Transmitter Functional Symbol Error Histogram (TFSEH) Updated Proposal

P802.3dj SMF IEEE P802.3dj Joint Electrical/Logic/Optical Ad Hoc Teleconference

December 16, 2025

TFSEH Functional Receiver (FRx) based Spec Summary

Figure 180–5—Transmitter OMA_{outer} each lane versus max(TECQ, TDECQ) and receiver sensitivity (OMA_{outer}) each lane versus TECQ

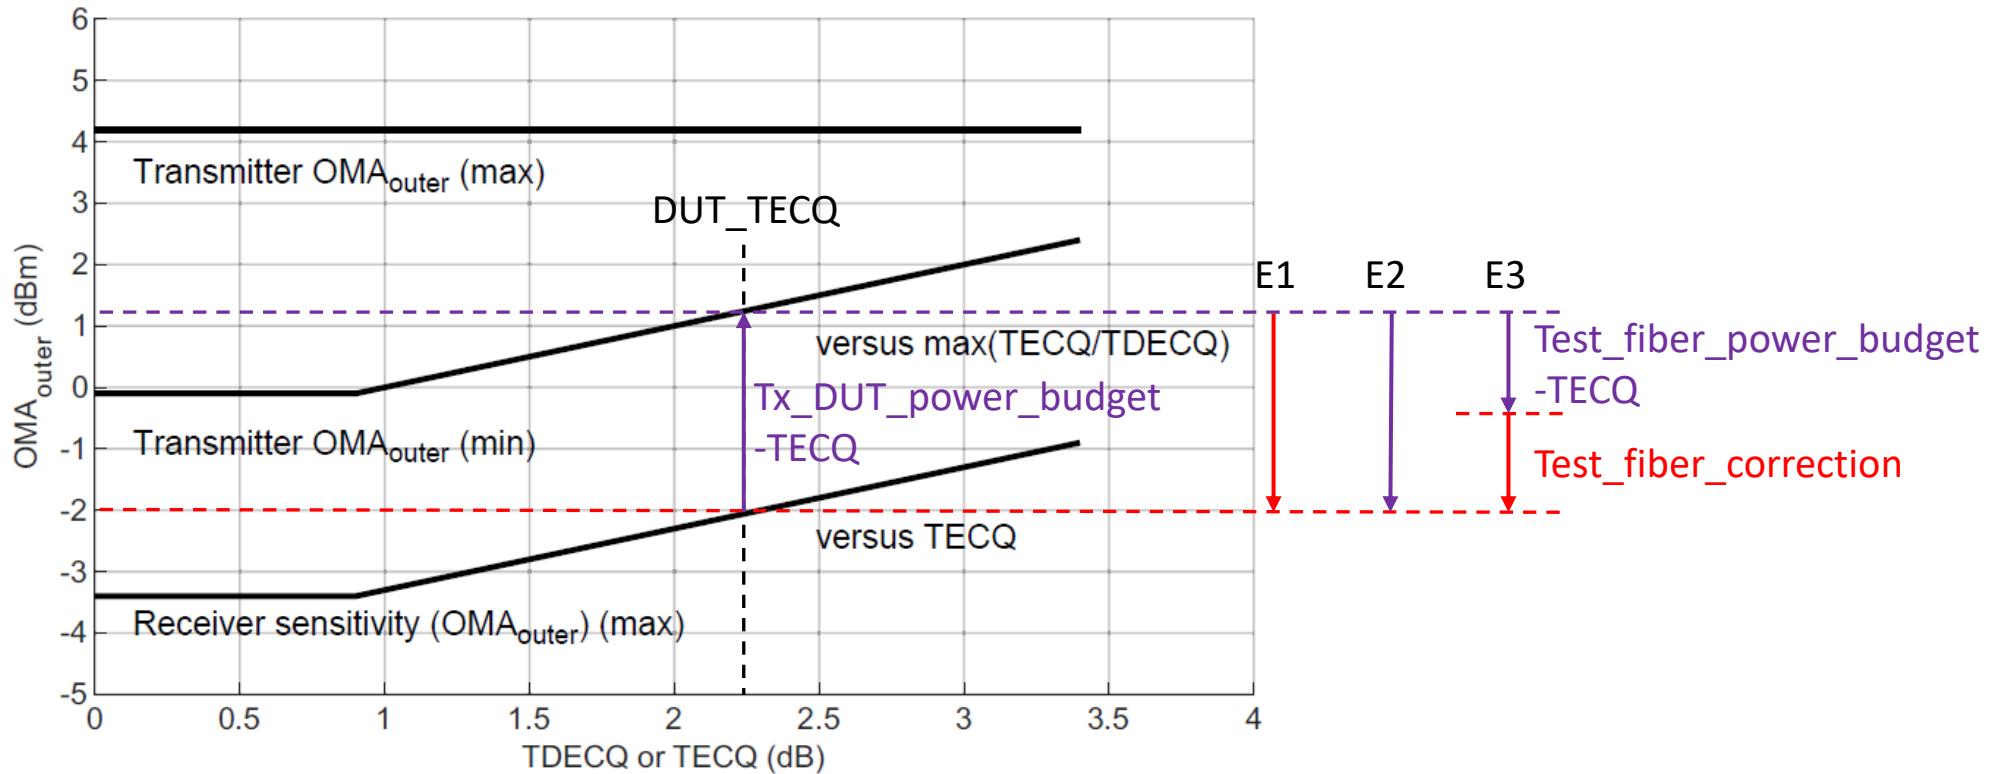
180.9.9.1 Test_fiber_correction exs. using referenced Figure 180-5

Test_fiber_correction = Tx_DUT_power_budget – Test_fiber_power_budget (180-28)

Figure 180-4—Receiver sensitivity (OMA_{outer} , each lane (max))

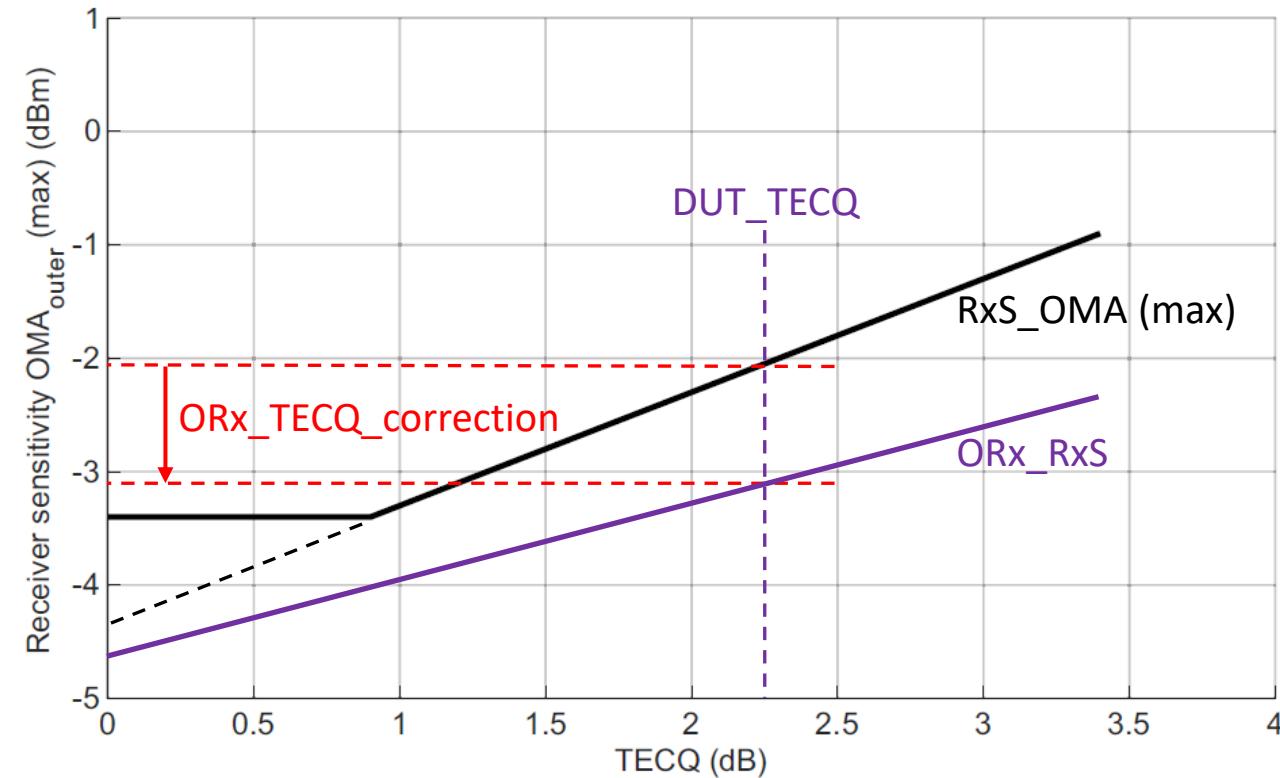
180.9.9.1 ORx_TECQ_correction ex. using referenced Figure 180-4

$$\text{ORx_TECQ_correction} = \text{RxS_OMA}@DUT_TECQ - \text{ORx_RS}@DUT_TECQ \quad (180-31)$$

— RxS_OMA@DUT_TECQ is the receiver sensitivity OMA (max) spec for TECQ ≥ 0.9 dB, extrapolated to TECQ = 0 dB (-4.3 dBm), at the TECQ measured for the transmitter under test

— ORx_RS@DUT_TECQ is the actual ORx receiver sensitivity OMA at the TECQ measured for the transmitter under test

Figure 180-5—Transmitter OMA_{outer} each lane versus max(TECQ, TDECQ) and receiver sensitivity (OMA_{outer}) each lane versus TECQ

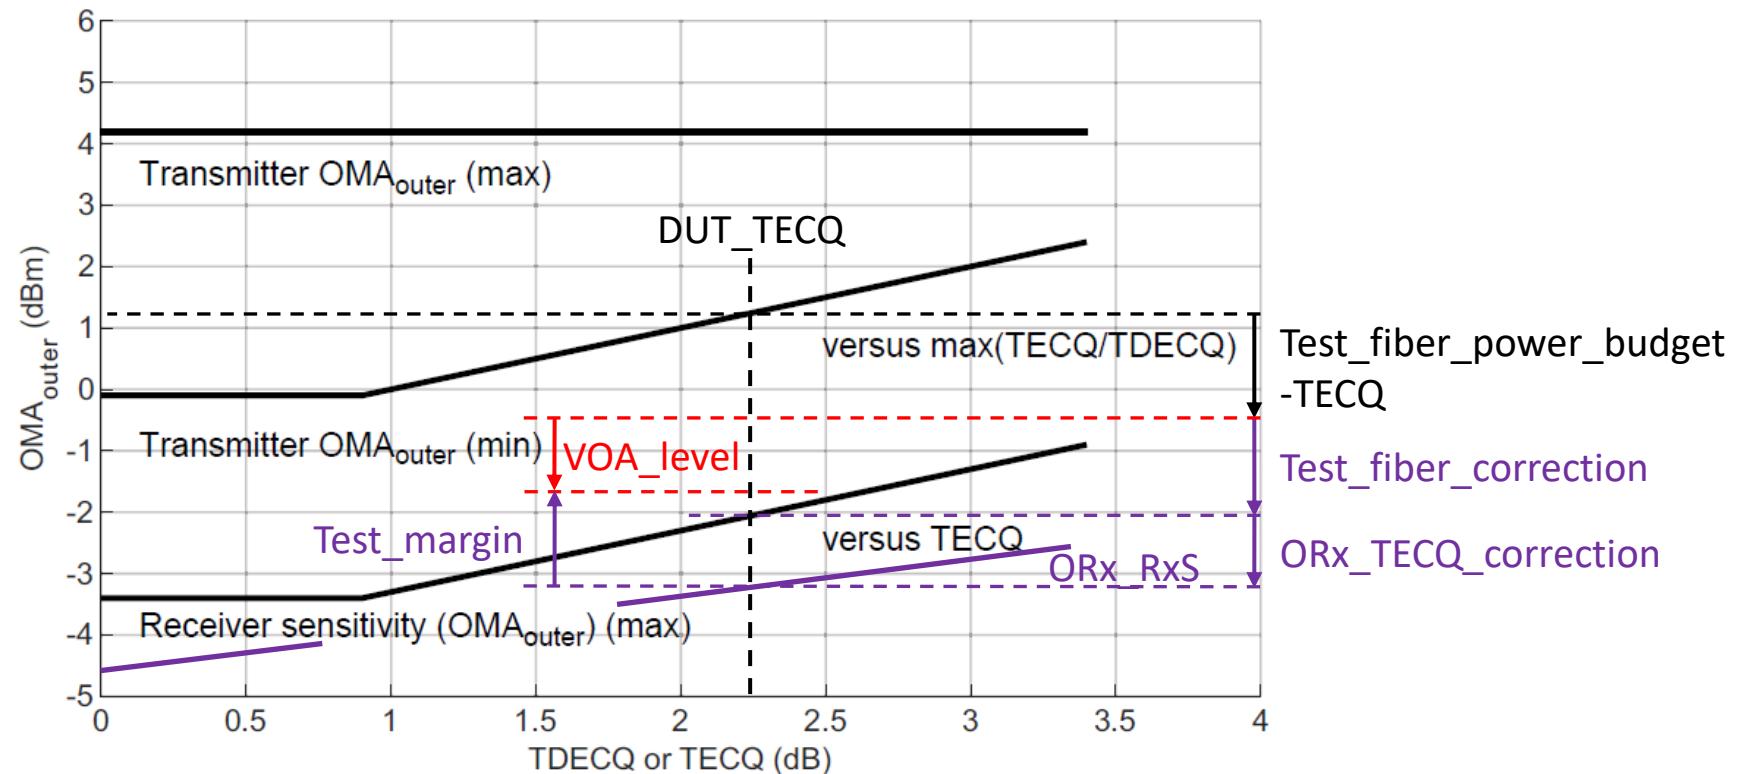
180.9.9.1 VOA_level ex. using referenced Figure 180-5

VOA_level = **Test_fiber_correction** + **ORx_TECQ_correction** – **Test_margin** (180-27)

Figure 180–4—Receiver sensitivity (OMA_{outer}), each lane (max)

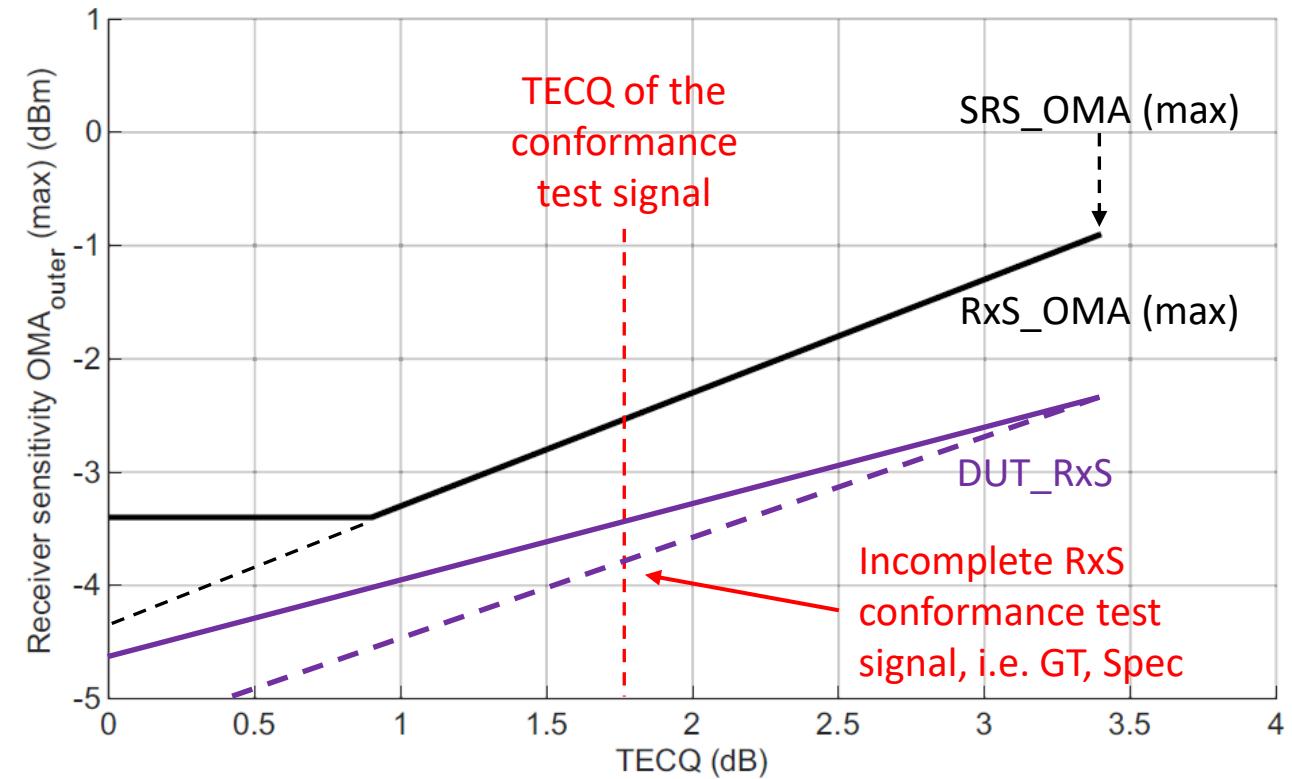
Appendix: Incomplete 180.9.15 RxS Spec found in FRx Testing

The receiver sensitivity (OMA_{outer}) of each lane shall be within the limits given in Table 180–8 if measured using a test pattern for receiver sensitivity in Table 180–14. The conformance test signal at TP3 meets the requirements for a transmitter followed by an attenuator.

The **TECQ of the conformance test signal** is measured according to 180.9.6, except that the test fiber is not used. The measured value of TECQ is then used to calculate the limit for receiver sensitivity (OMA_{outer}) as specified in Table 180–8.

The receiver sensitivity (OMA_{outer}) of each lane shall be within the limits given in Table 180–8 if measured using a test pattern for receiver sensitivity in Table 180–14. ~~The conformance test signal at TP3 meets the requirements for a transmitter followed by an attenuator.~~

The conformance test signal at TP3 is the stressed receiver sensitivity test signal, specified in 180.9.16, except that the Gaussian noise generator and sinusoidal interferer are both turned off (the sinusoidal jitter remains on).

The stressed receiver sensitivity conformance test signal, specified in 180.9.16, needs additional review to confirm it is worst-case stress. For example, the sinusoidal jitter specification is incomplete. The above receiver sensitivity conformance test signal would be benefit from this.
